Meeting Agenda

Historic Zoning Commission

Monday, September 11, 2023

PROPOSED NEW DOOR

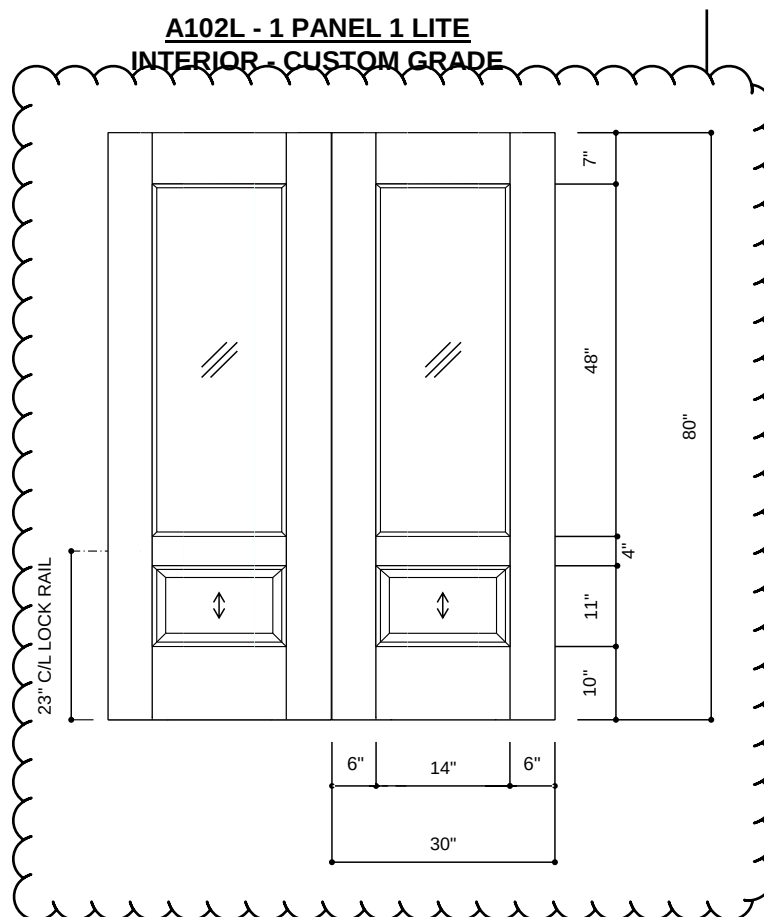
BACKGROUND:
The application came before the Design Review Committee during its August 2023 meeting to seek feedback on the proposal to replace the existing non-historic door. Based on the photos provided in the application showing the building in 1904 and 1971, it is believed that the current doors on the building are not original. The Guidelines recommend restoring an altered storefront to its original design using historic photographs when possible. Where evidence does not exist, use traditional designs and arrangements. The proposed maghony doors with glass appear to match the doors that are seen in the 1904 photograph and are appropriate.

RECOMMENDATION:
Staff recommends approval of this application with the following conditions:
1. The proposed logo on the windows must apply for a separate administrative COA for the signage.
2. The application must meet all the requirements of the City of Franklin prior to the issuance of a building permit.
3. Any additional changes to the approved plans must be returned to the Preservation Planner or the Historic Zoning Commission for review and approval.

An Addition and Interior Renovation for:
The Roberts / Berry Bldg.
236 Public Square, Franklin, TN
Job Number: 23-004

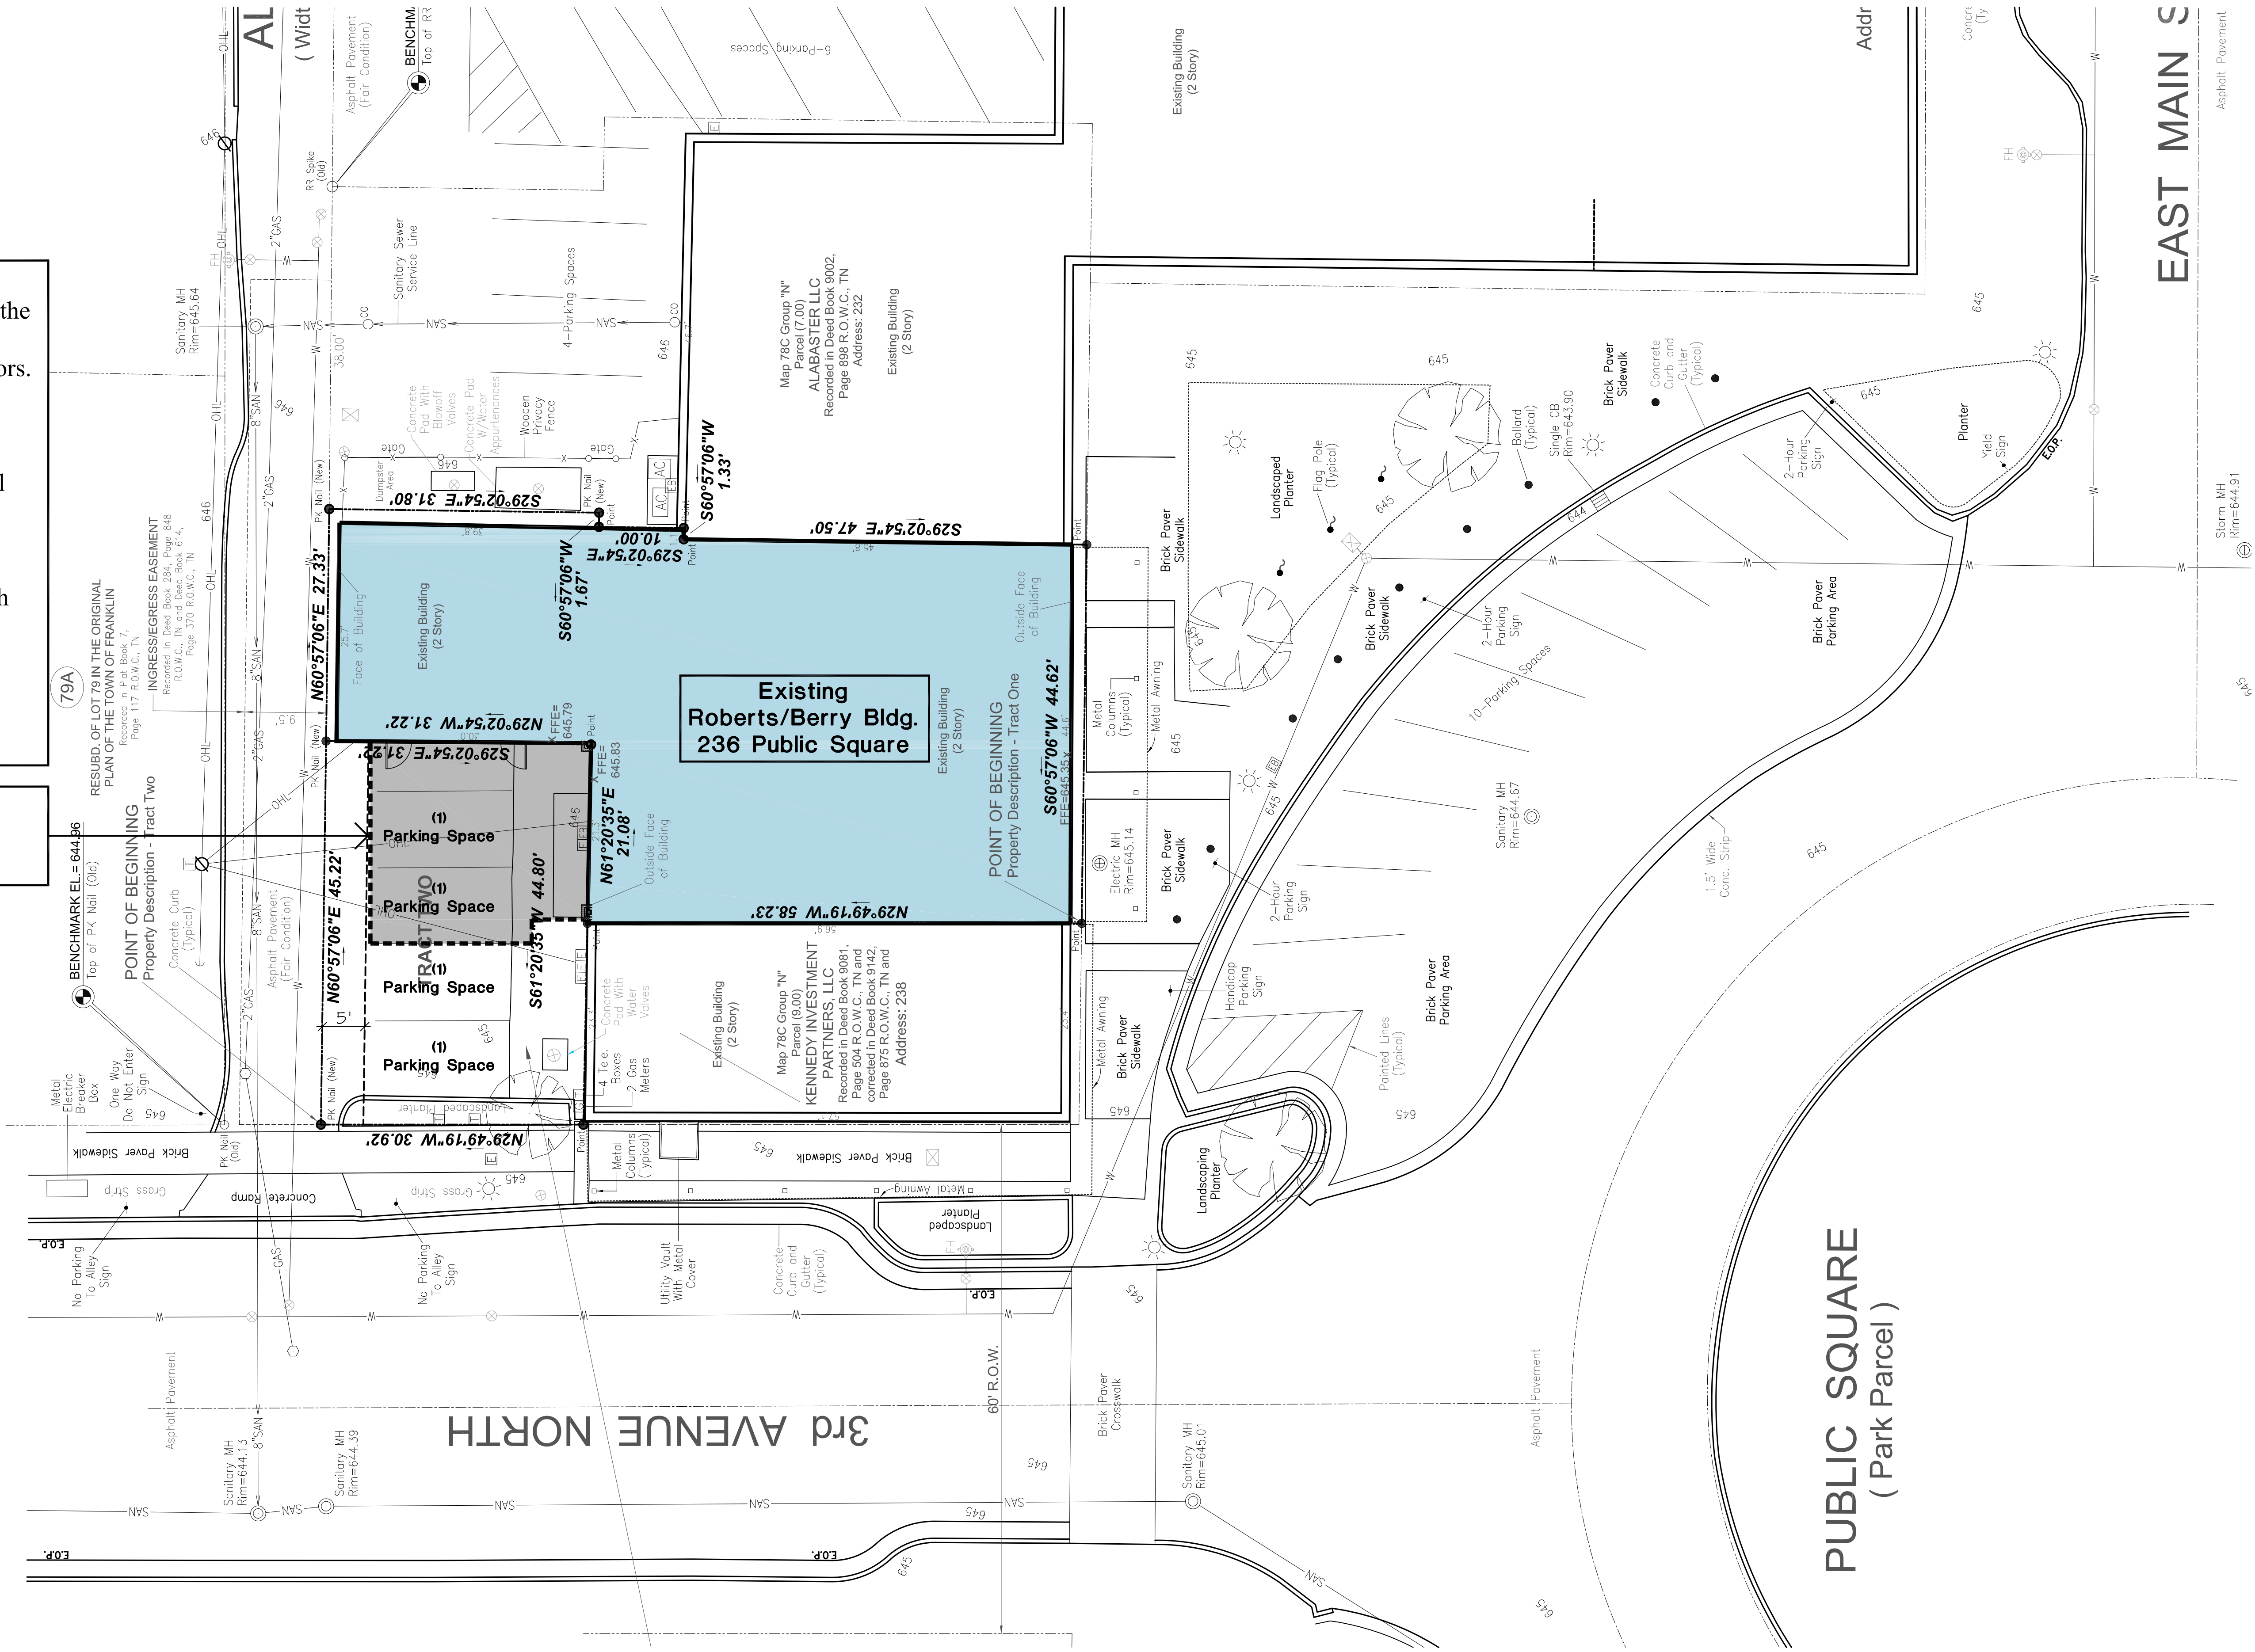
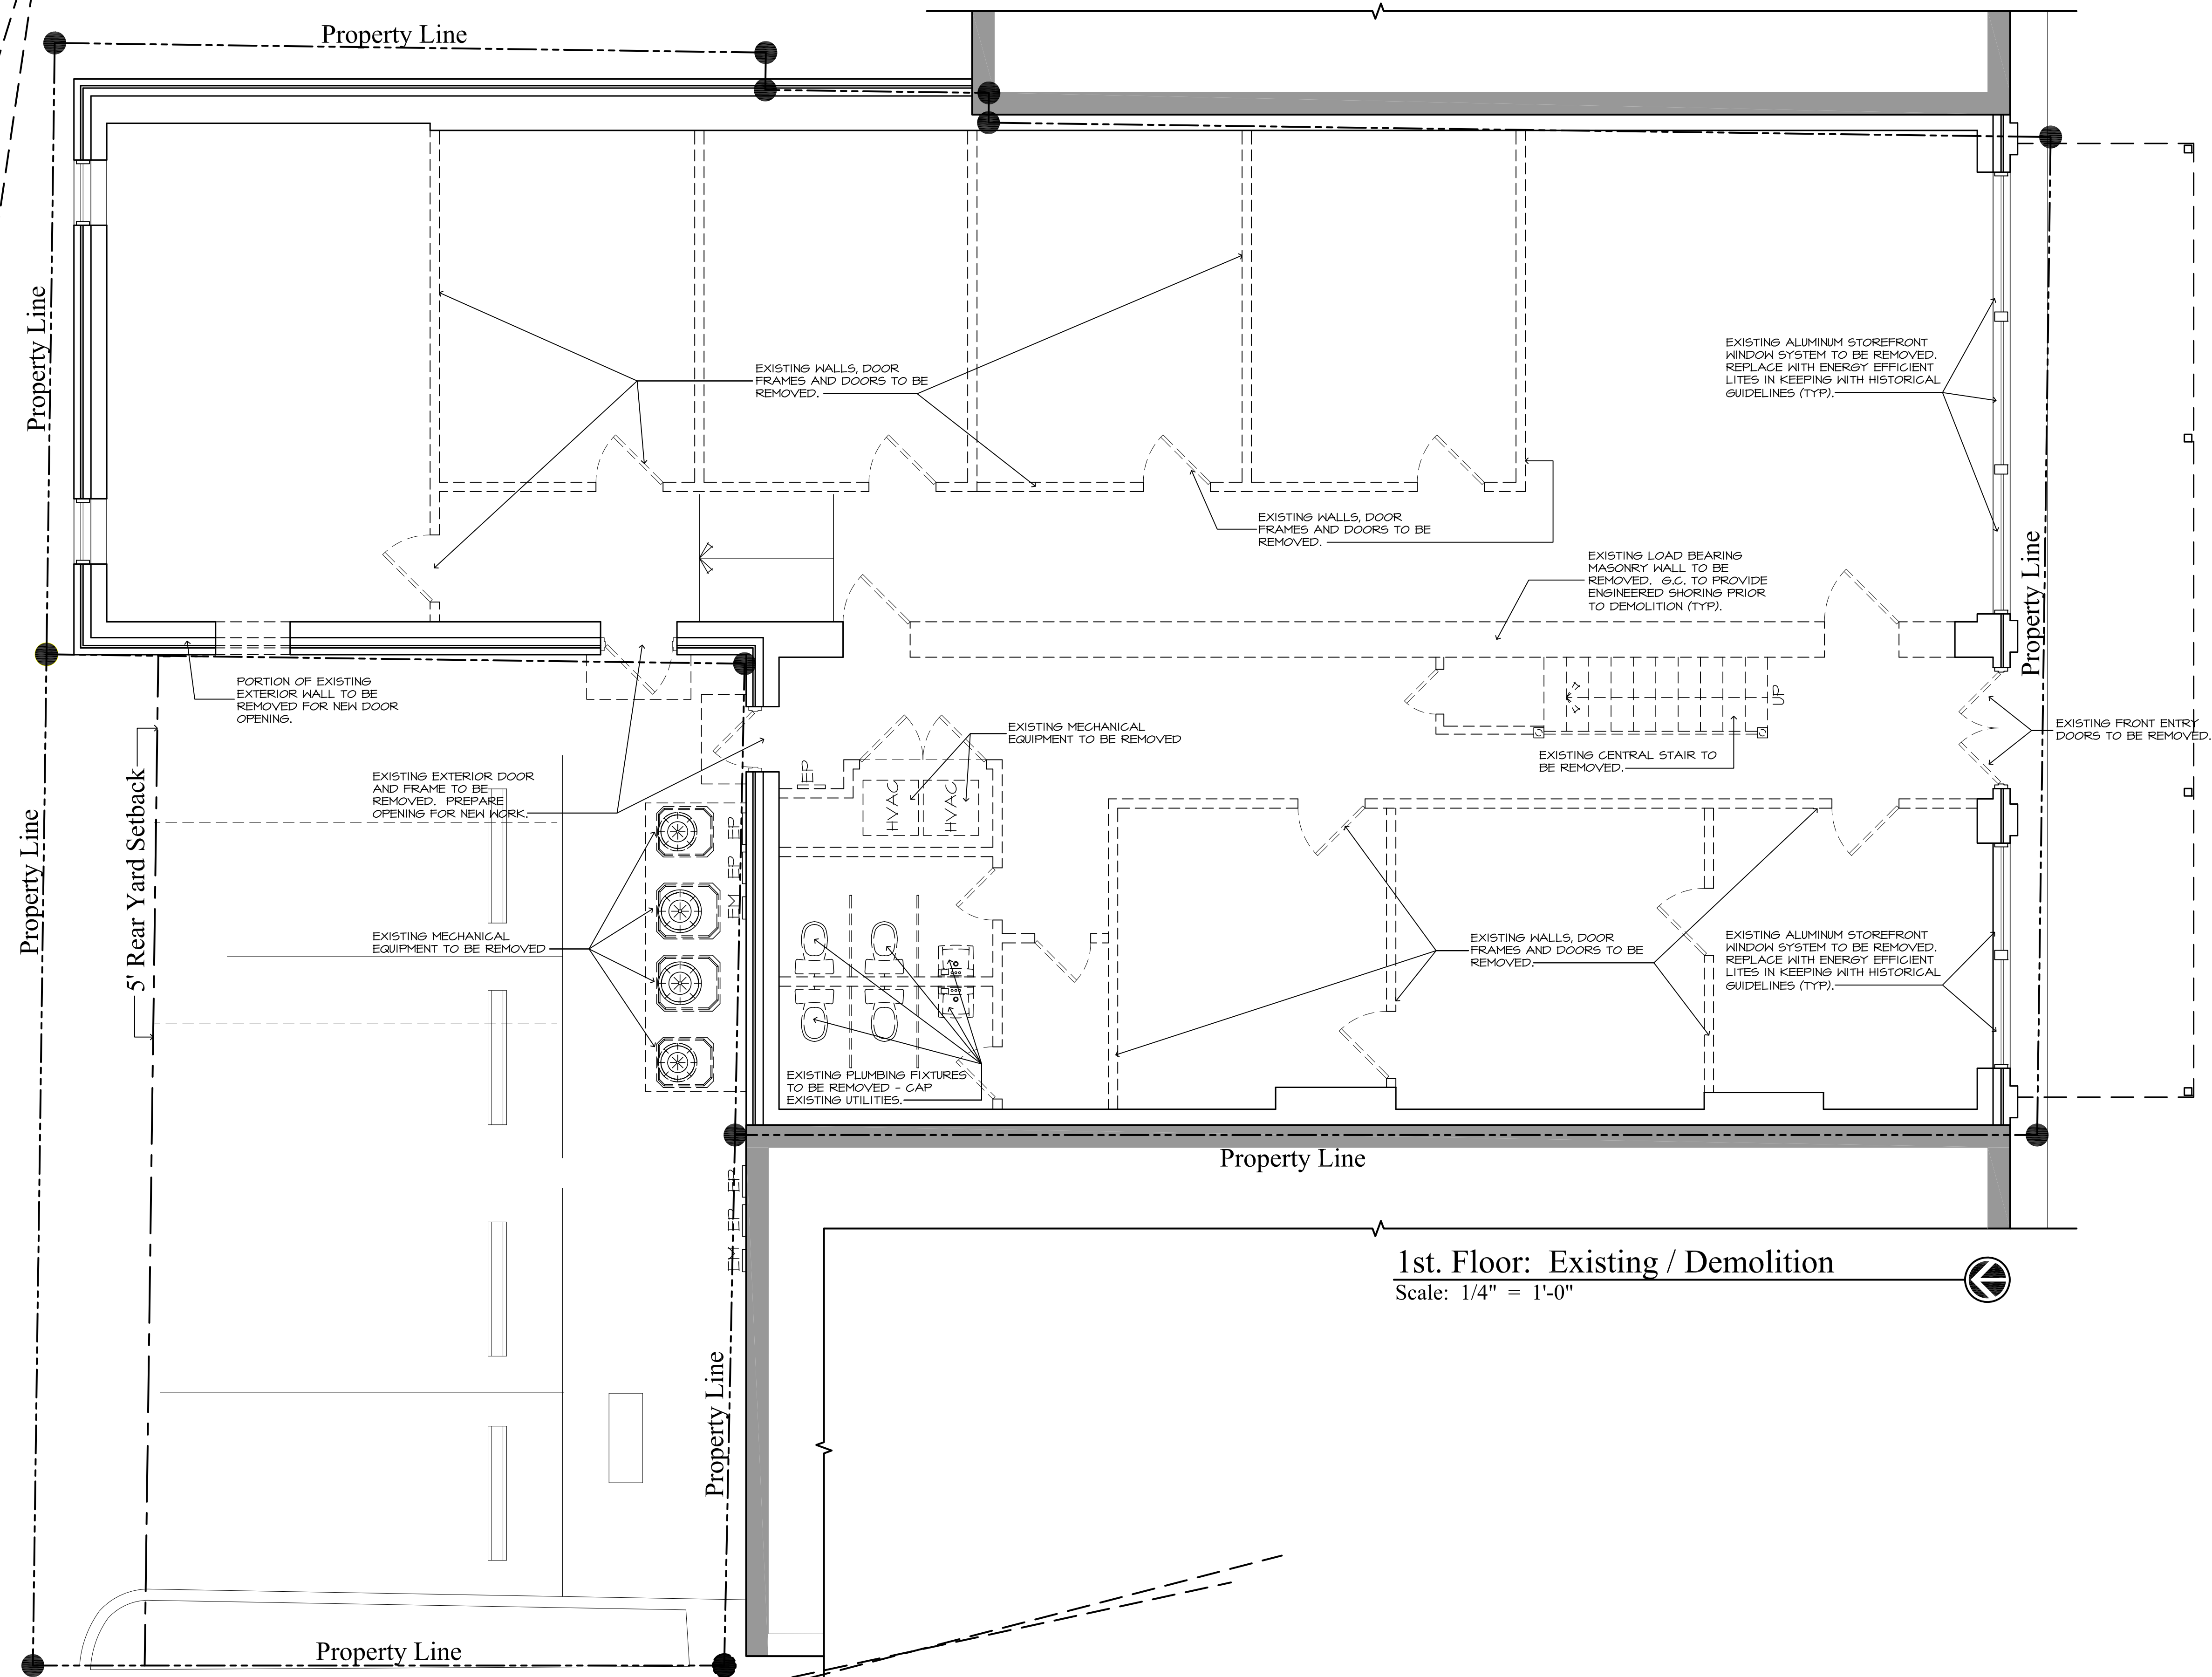
- Design additions to be subordinate in appearance to the historic building. Considerations include placement, size, massing, scale, height, setbacks, and materials.
- Avoid removal of sections of historic walls to accommodate additions unless significant structural deficiencies can be demonstrated. Design additions so that owners may remove the additions and restore the original facade if so desired.

Staff recommends denial of this application based on the following grounds:

1. Design additions to be subordinate in appearance to the historic building.
2. Avoid removal of sections of historic walls to accommodate additions unless significant structural deficiencies can be demonstrated.

1. The lots owned by the property owner must be consolidated prior to construction to be in compliance with the rear lot setback requirements.
2. The proposed brick and mortar shall match the historic brick, with a material sample of the brick and mortar subject to approval by the Preservation Planner or the Historic Zoning Commission.
3. The proposal for front door replacement shall be submitted as a separate COA application.
4. The application must meet all the requirements of the City of Franklin prior to issuance of a building permit.
5. Any additional changes to the approved plans must be returned to the Preservation Planner or the Historic Zoning Commission for review and approval.
